Technical report on Anode part

As per our Commercial Dept. request, we verified installation for our part # on Mercury
sterndrive Bravo III-2004

Technical spec. : Mercury Bravo III-2004 engine; manufacturing year 2010

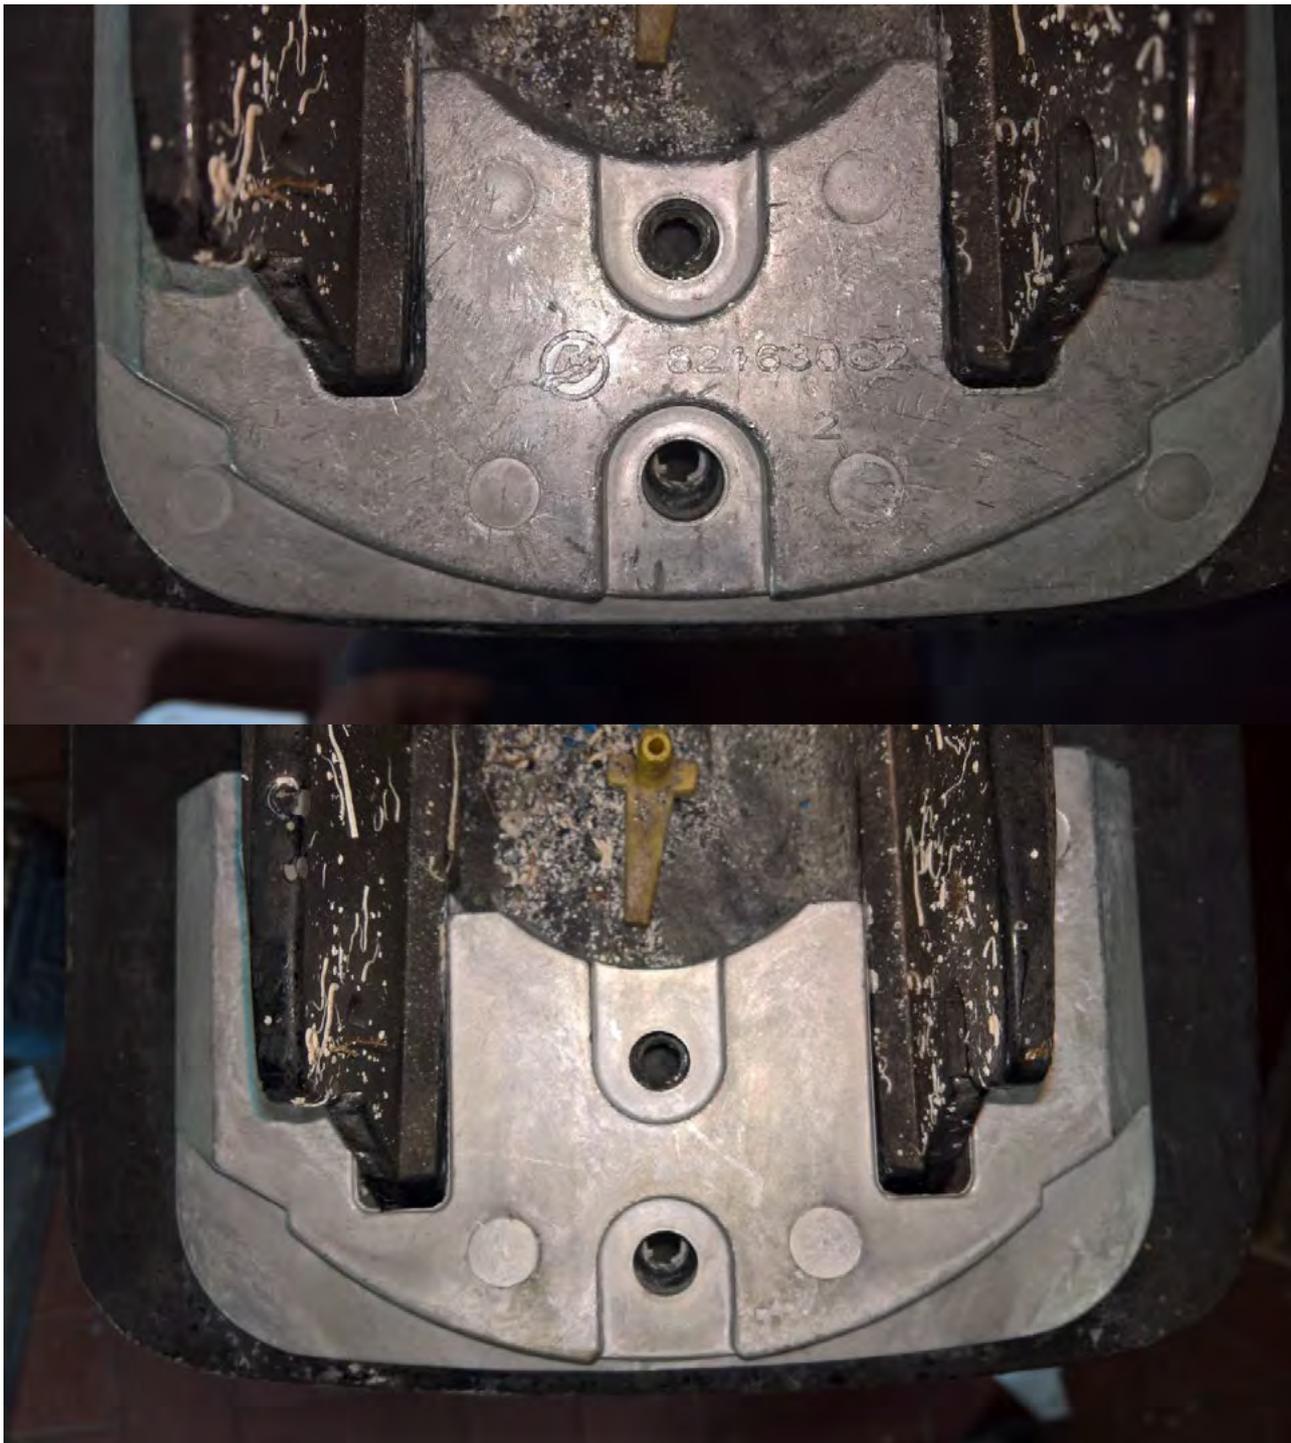
As shown in the pictures, all genuine parts and O
Bravo III-2004 sterndrive, year 2010

anodes were installed with no problem on the
